ZONING AMENDMENT

& SUBDIVISION STAFF REPORT Date: October 20, 2011

APPLICANT NAME MAWSS Shelton Beach Facility

CONTEMPLATED USE Subdivision approval to create 1 lot, and Zoning approval

SUBDIVISION AND ZONING DETAIL

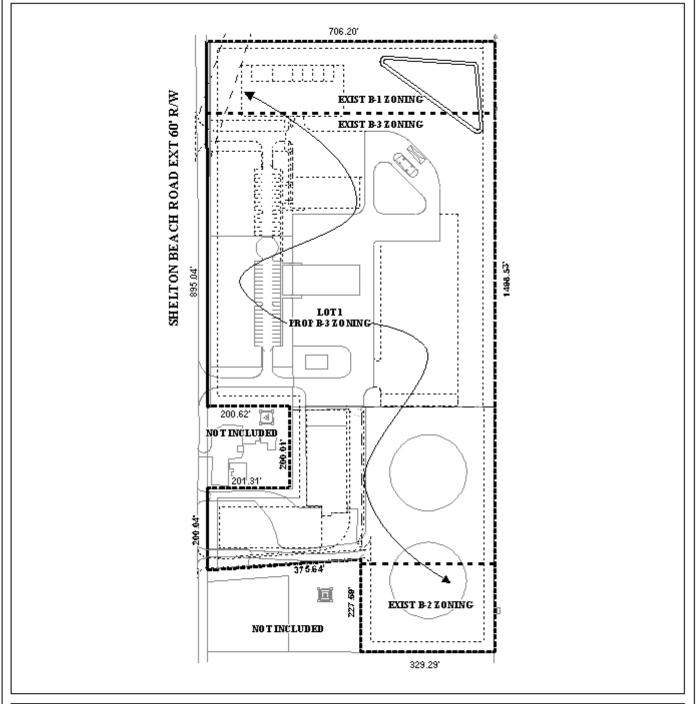
The 25-foot minimum building setback is depicted, but should only be from road frontages, not adjacent properties. The plat should be revised to correctly depict the setback line.

The lot is labeled with its size in acres but not in square feet. The plat should be revised to indicate the size of the lot in square feet.

- 2) Labeling of the lot with its size in square feet;
- 3) Depiction of the 25-foot minimum building setback line from Shelton Beach Road Extension;
- 4) Depiction and provision of a 25-foot wide natural vegetative buffer where the site abuts residential and multi-family properties to the East and North;

SITE PLAN

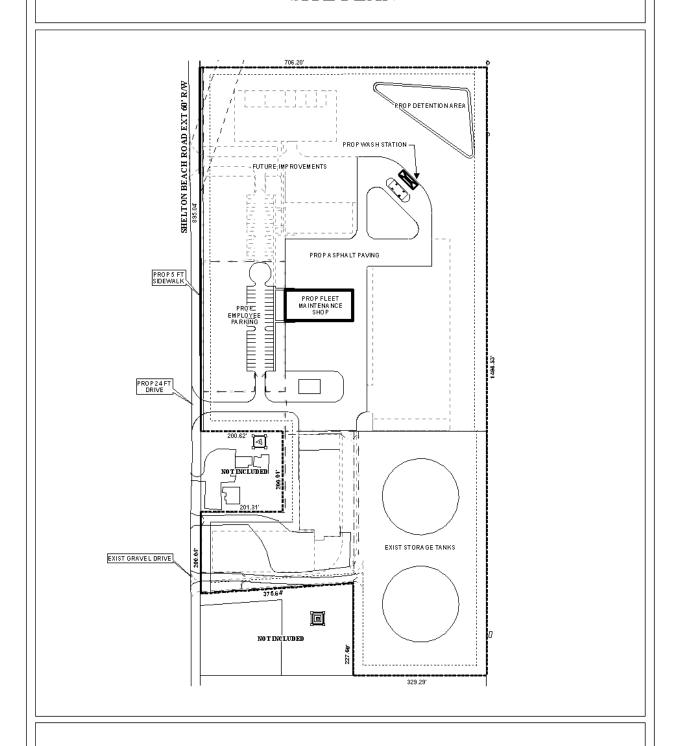
While Shelton Beach Road is a minor street, access management is a concern due to the type of traffic that will be associated with the proposed fleet maintenance facility and storage yards. The site plan submitted with the Zoning application indicates four (4) curb-cuts onto Shelton Beach Road. As the Planning Approval and PUD approvals are site plan specific, and as they are scheduled for consideration at a later date, curb-cuts should be limited to an approved Planning Approval / PUD site plan.

- 1) Placement of a note on the plat stating that curb-cuts for the lot are limited to an approved Planned Unit Development, with the size, location, and design to be approved by Traffic Engineering and conform to AASHTO standards;
